**Joint Neighborhood Associations Shared Letter
2-1-2010**

Re: **Stuart Street Study Area Zoning Recommendations.**

STUART STREET PLANNING AREA - EXISTING CONDITIONS WITH EXISTING ZONING

STUART STREET PLANNING AREA - EXISTING CONDITIONS WITH PROPOSED ZONING

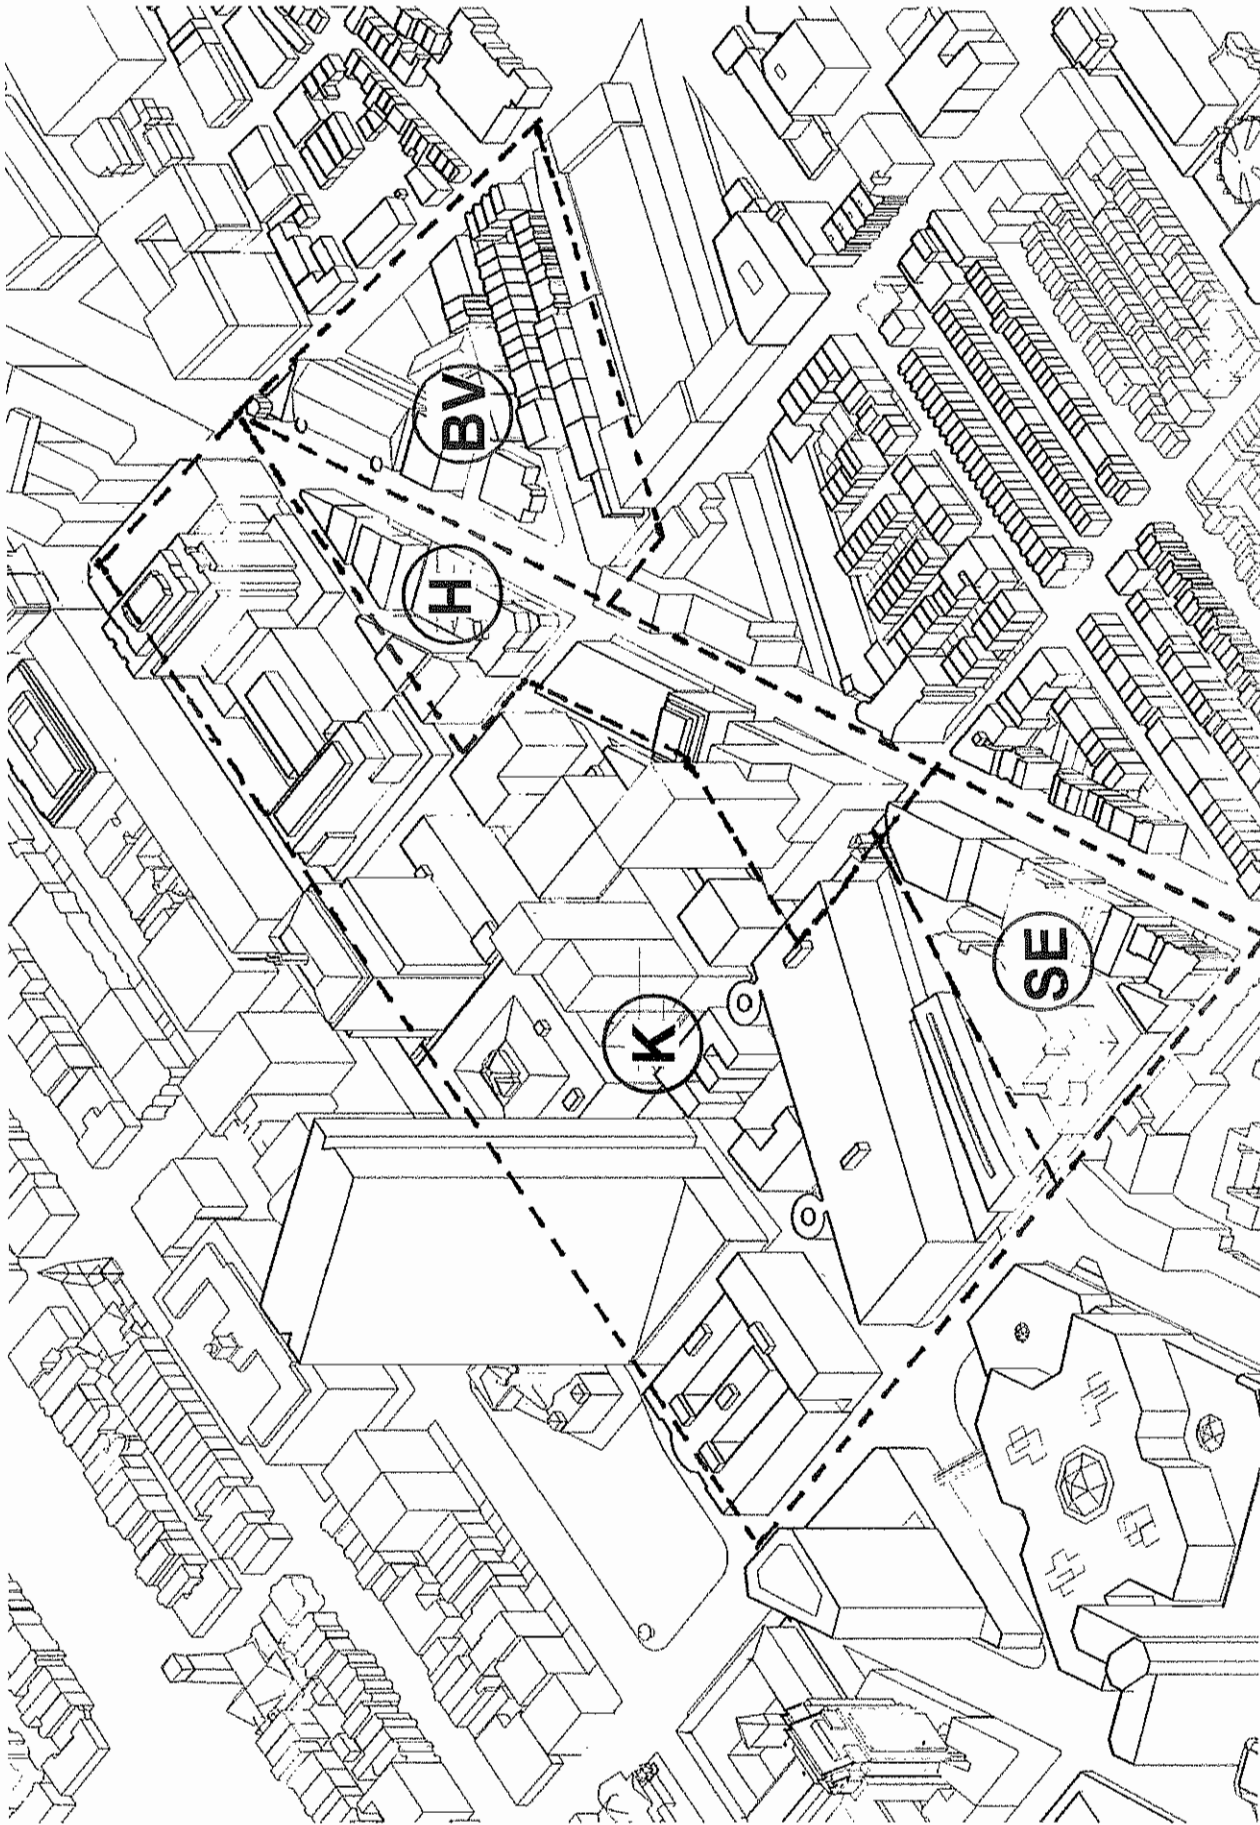
1. Divide the area into four zoning sub-districts*.

In the spirit of fostering a vibrant area that also respects the historic urban context and scale of the surrounding neighborhoods, the new zoning should avoid taking a "blanket" approach to the entire study area. In particular, the new zoning needs to provide a more appropriate architectural transition from adjacent low-rise historic neighborhoods to a maximum allowable height, as defined by the iconic old Hancock Tower. Therefore, the study area should continue to be divided into several zoning districts, each addressing its unique urban context.

- This area along Columbus Ave. should serve as a buffer to the abutting Bay Village and South End Neighborhoods. Zoning must be more in keeping with the current As-of-Right and Enhanced zoning, i.e., 80ft/6FAR and 100ft/7 FAR.

- This district could be modified from current zoning to allow an increased maximum height of 100 ft along Columbus Ave. (the height of the Castle Armory shed) and 65 ft along Arlington St. to step down to existing neighborhood context. The parcel, currently known as the Sawyer Parking lot, should fall within the zoned 65 ft height limit.

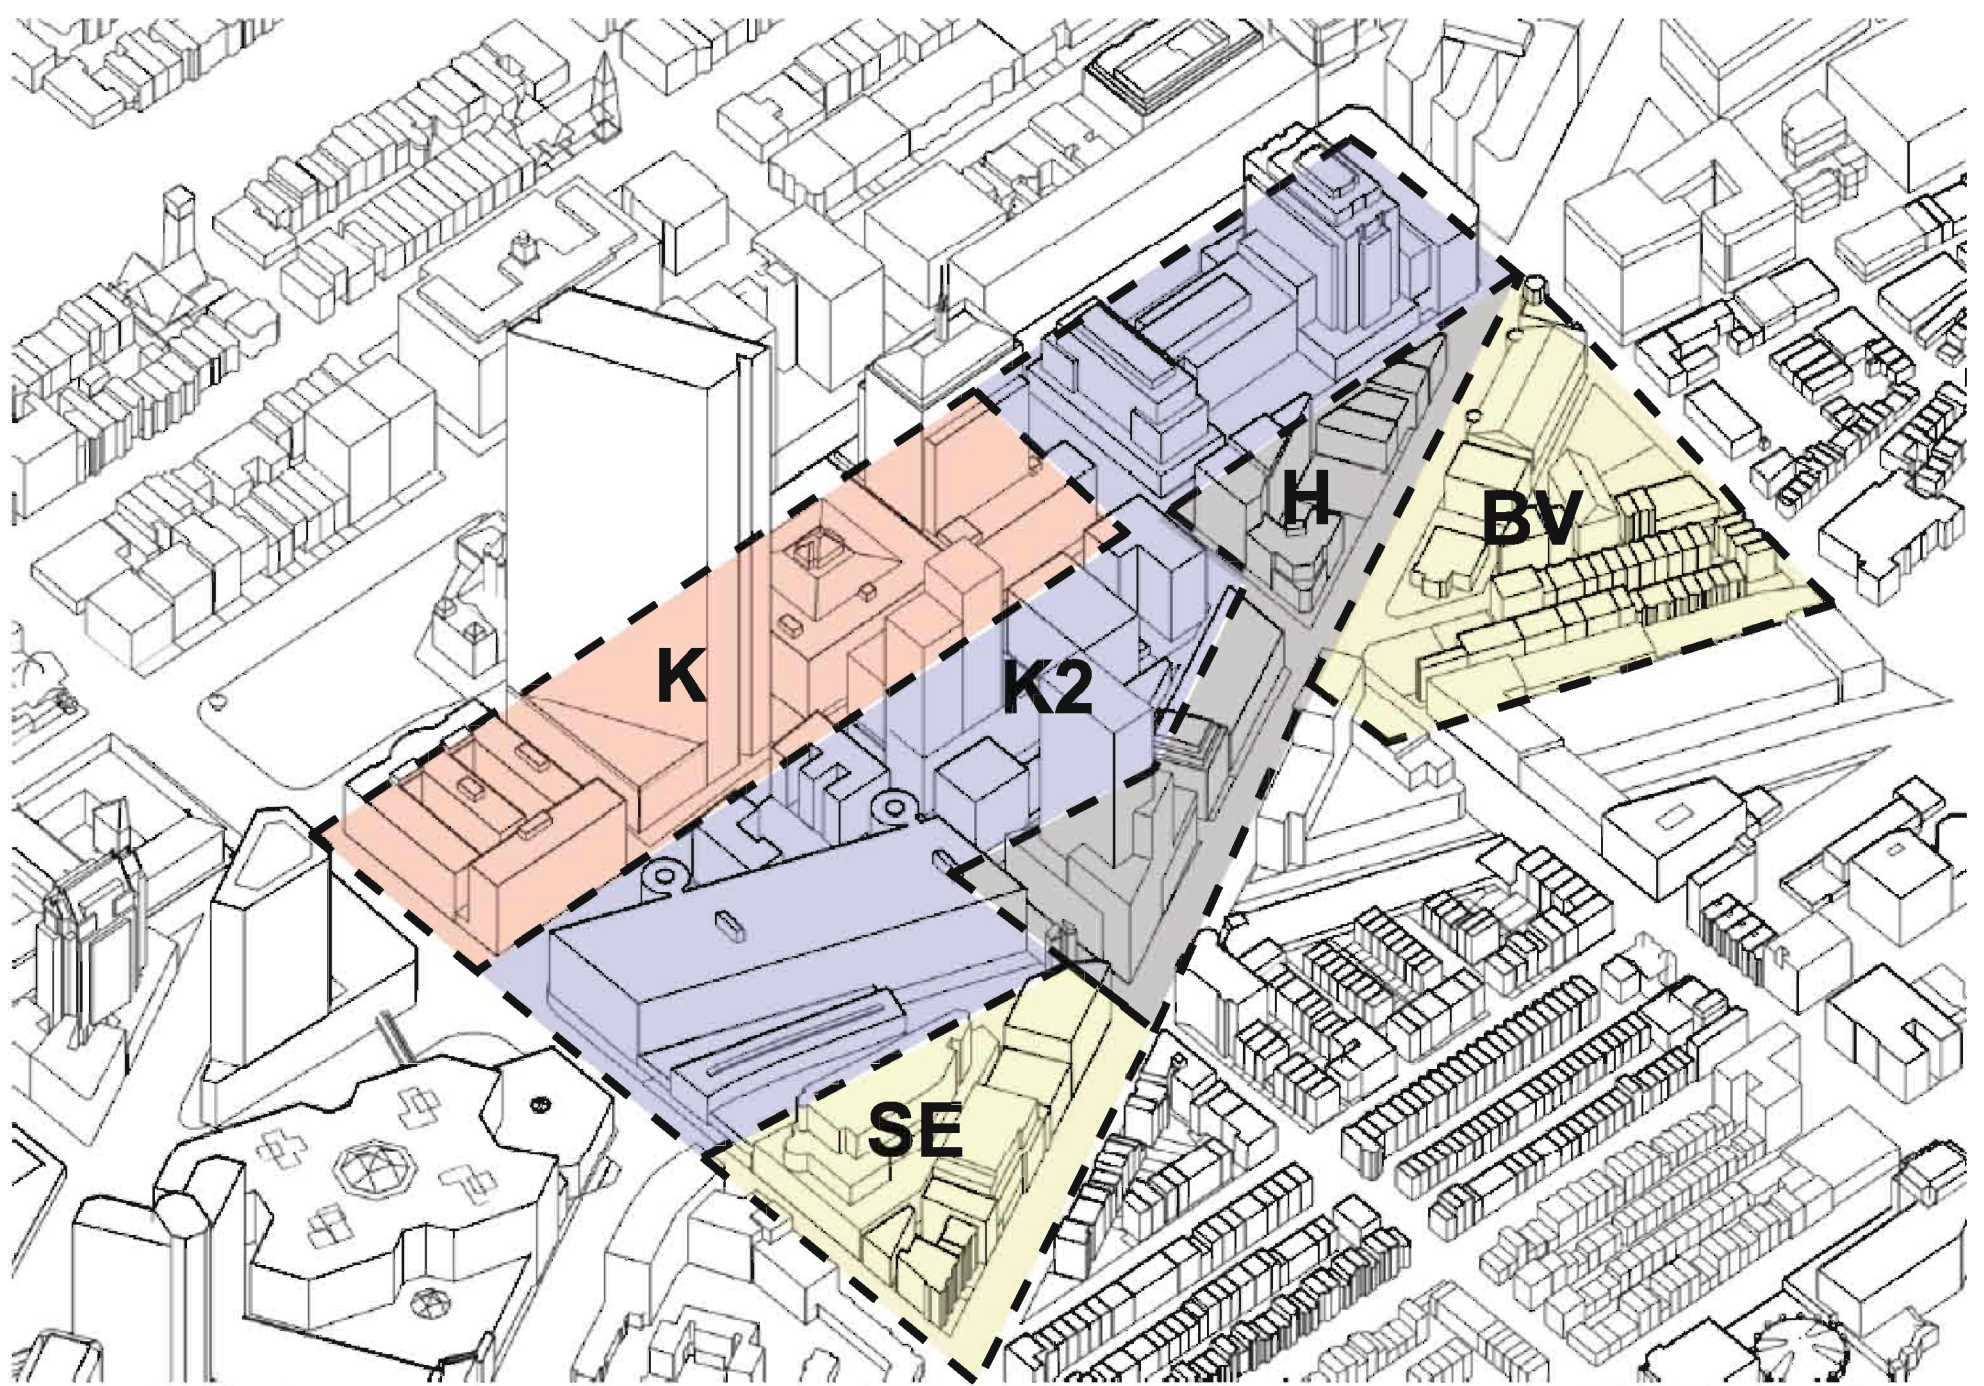
We would like to revise Paragraph 1.d. in our February 1, 2010 letter to say:

- The “K” IPOD is an area bordered by St. James Avenue and Berkeley, Stuart and Dartmouth Streets. This area should maintain its existing zoning in order to provide an appropriate edge to Copley Square and the Back Bay business and residential areas to the North. It will also help ensure that any new building heights will maintain important view corridors to Trinity Church and along Copley Square.

- As-of-Right: 150ft/ FAR10
 - Enhanced: 356 ft/FAR15

***(A map of the 5 sub-districts can be found at the end of this document)**

STUART STREET PLANNING AREA - EXISTING CONDITIONS WITH EXISTING ZONING

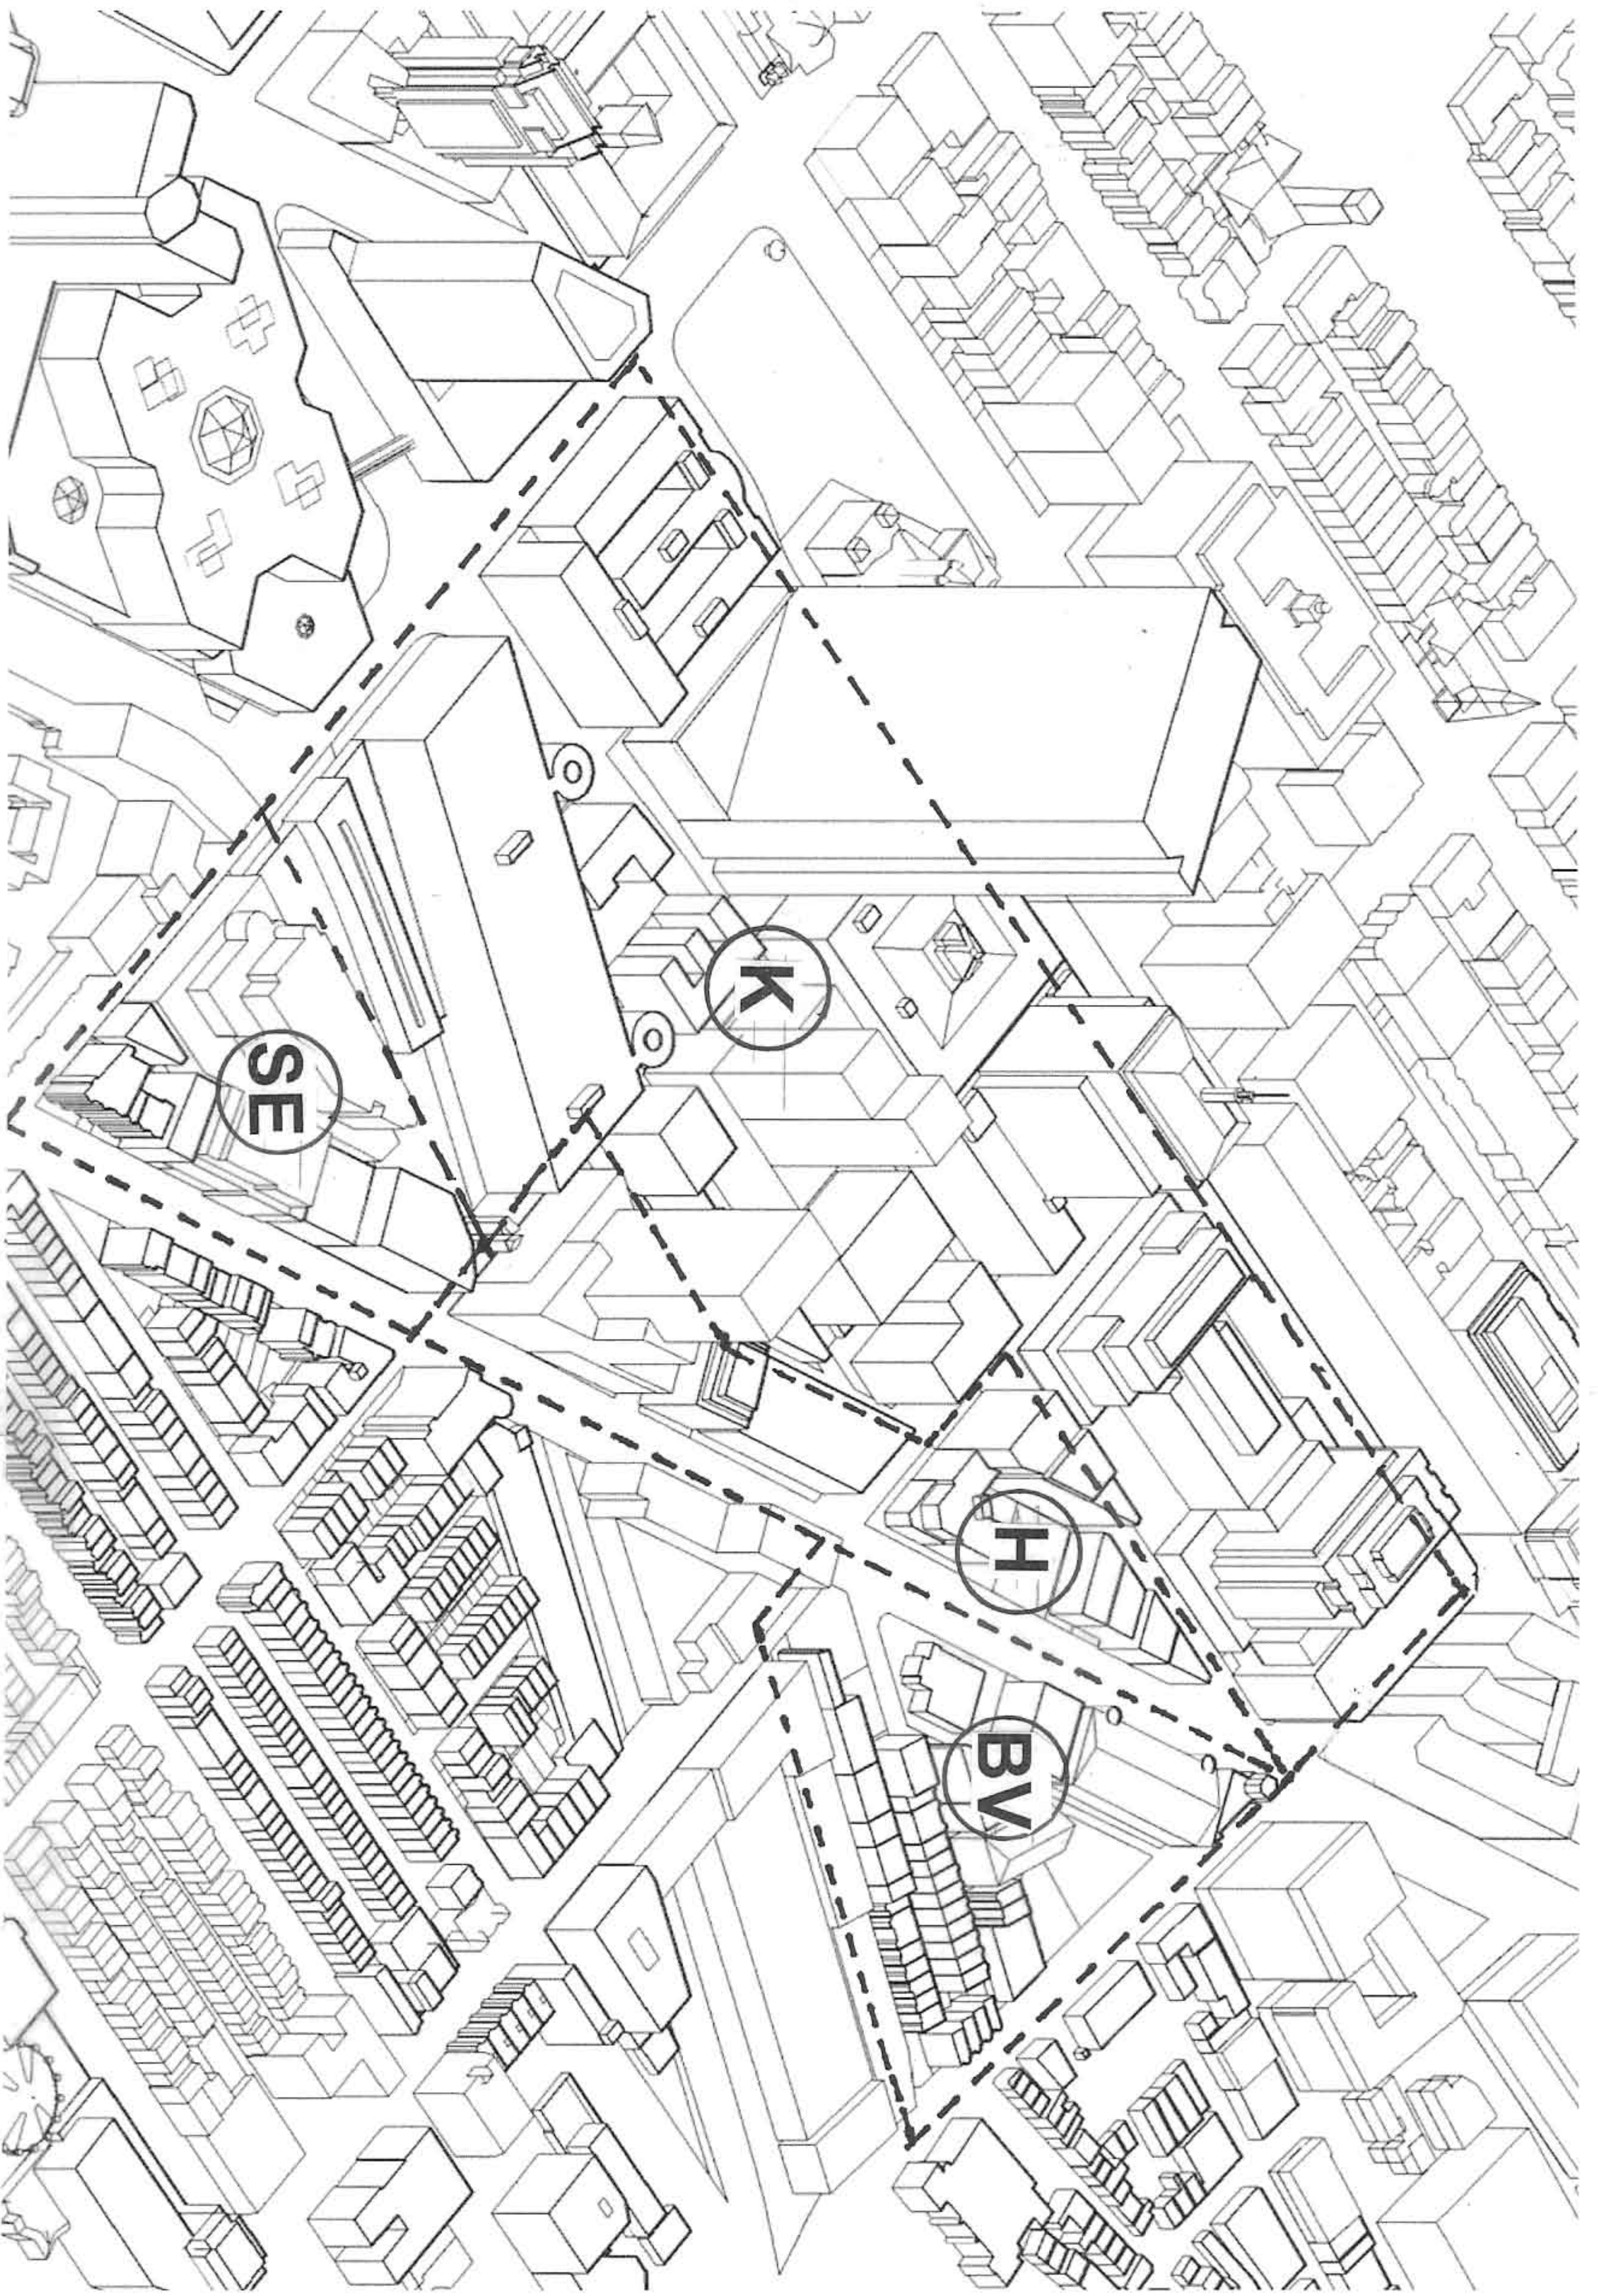
In the spirit of fostering a vibrant area that also respects the historic urban context and scale of the surrounding neighborhoods, the new zoning should avoid taking a "blanket" approach to the entire study area. In particular, the new zoning needs to provide a more appropriate architectural transition from adjacent low-rise historic neighborhoods to a maximum allowable height, as defined by the iconic old Hancock Tower. Therefore, the study area should continue to be divided into several zoning districts, each addressing its unique urban context.

- This district could be modified from current zoning to allow an increased maximum height of 100 ft along Columbus Ave. (the height of the Castle Armory shed) and 65 ft along Arlington St. to step down to existing neighborhood context. The parcel, currently known as the Sawyer Parking lot, should fall within the zoned 65 ft height limit.
